JNU GLACIER HIGHWAY  
 SAFETY IMPROVEMENTS  
 (HSIP)

GUARDRAIL TYPICAL SECTION  
 AND DETAILS

ADDENDUM NUMBER		
ATTACHMENT NUMBER		
RECORD OF REVISIONS		
No.	DATE	DESCRIPTION
1	8/2/16	ADDENDUM 2
2	8/8/16	ADDENDUM 3

**ESTIMATE OF QUANTITIES  
AND SUMMARIES**

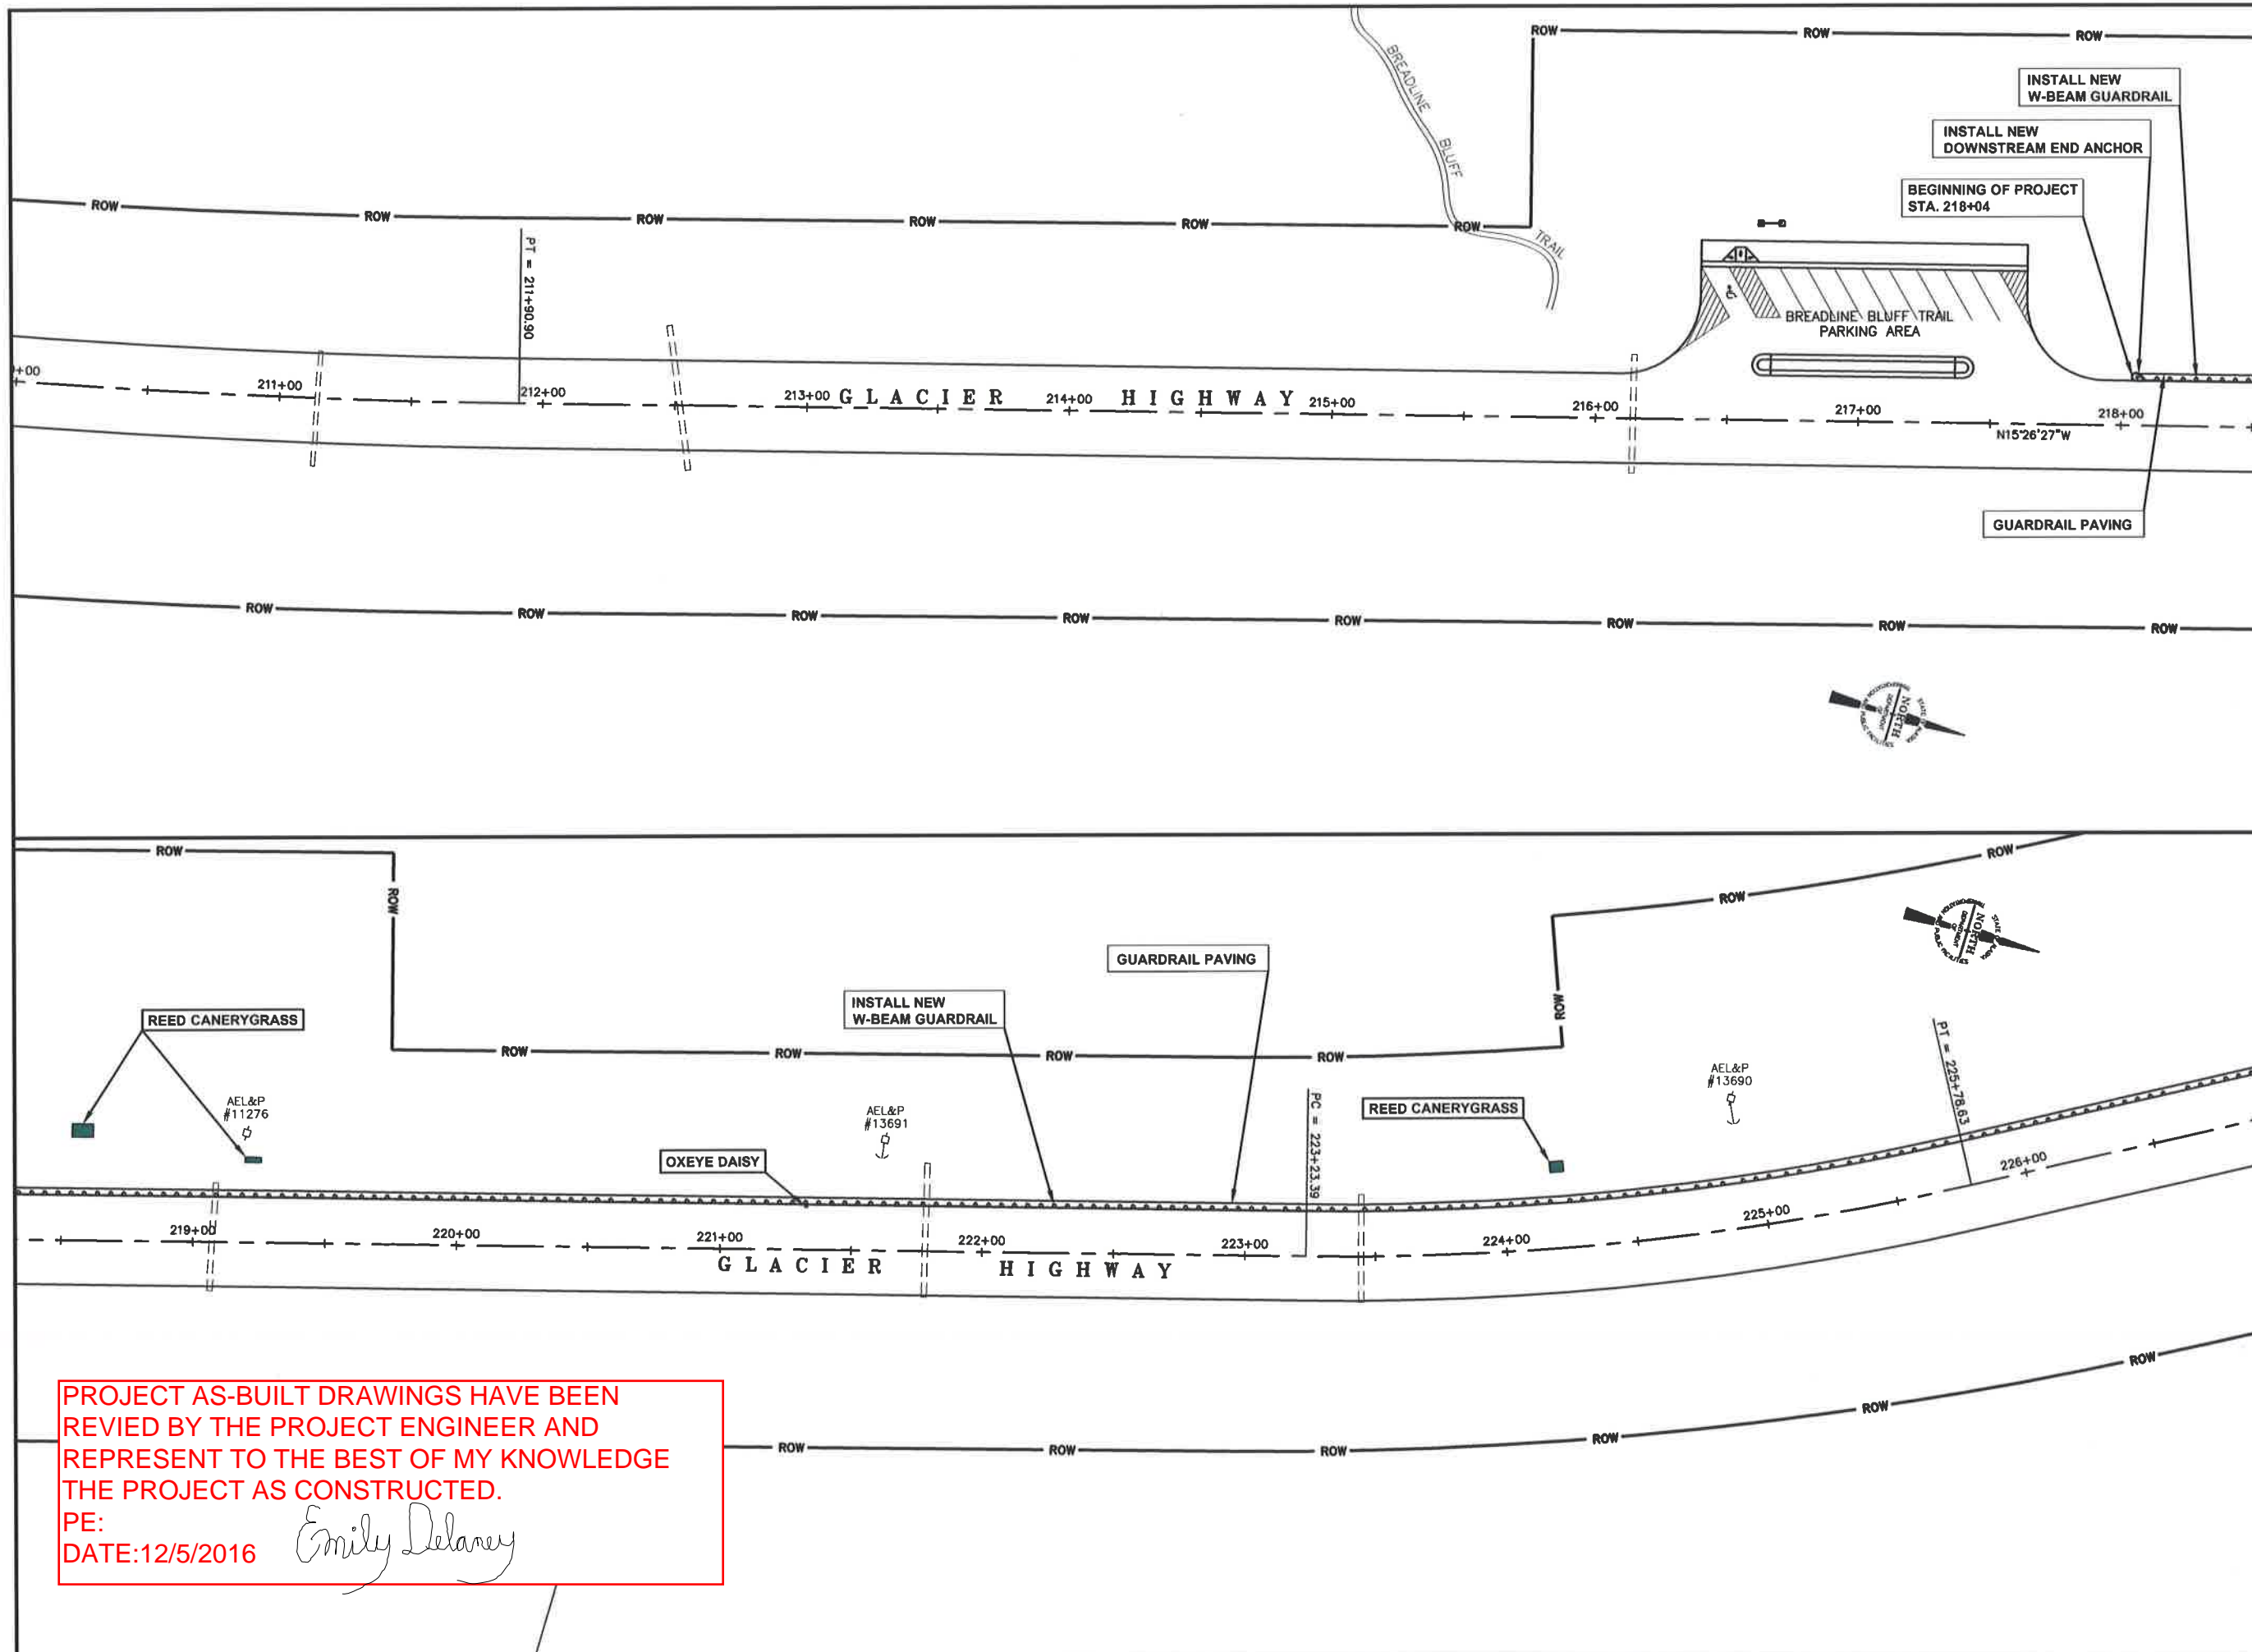
BASIC BID - ESTIMATE OF QUANTITIES			
ITEM NUMBER	ITEM DESCRIPTION	PAY UNIT	QUANTITY
201 (7)	INVASIVE PLANT SPECIES CONTROL, REMOVAL AND DISPOSAL	SQUARE YARD	<del>1,200</del> <b>11</b>
606 (1)	W-BEAM GUARDRAIL	LINEAR FOOT	<del>2,911</del> <b>2937.5</b>
606 (13)	PARALLEL GUARDRAIL TERMINAL	EACH	1
629 (1)	GUARDRAIL PAVING	LINEAR FOOT	2,981
633 (2)	SEDIMENT BARRIER	LINEAR FOOT	<del>275</del> <b>225</b>
640 (1)	MOBILIZATION AND DEMOBILIZATION	LUMP SUM	ALL REQUIRED
641 (1)	EROSION, SEDIMENT AND POLLUTION CONTROL ADMINISTRATION	LUMP SUM	ALL REQUIRED
641 (2)	TEMPORARY EROSION, SEDIMENT, AND POLLUTION CONTROL	CONTINGENT SUM	ALL REQUIRED
641 (6)	WITHOLDING	CONTINGENT SUM	ALL REQUIRED
642 (1)	CONSTRUCTION SURVEYING	LUMP SUM	ALL REQUIRED
643 (2)	TRAFFIC MAINTENANCE	LUMP SUM	ALL REQUIRED
643 (15)	FLAGGING	CONTINGENT SUM	ALL REQUIRED
643 (23)	TRAFFIC PRICE ADJUSTMENT	CONTINGENT SUM	ALL REQUIRED
643 (25)	TRAFFIC CONTROL	CONTINGENT SUM	ALL REQUIRED
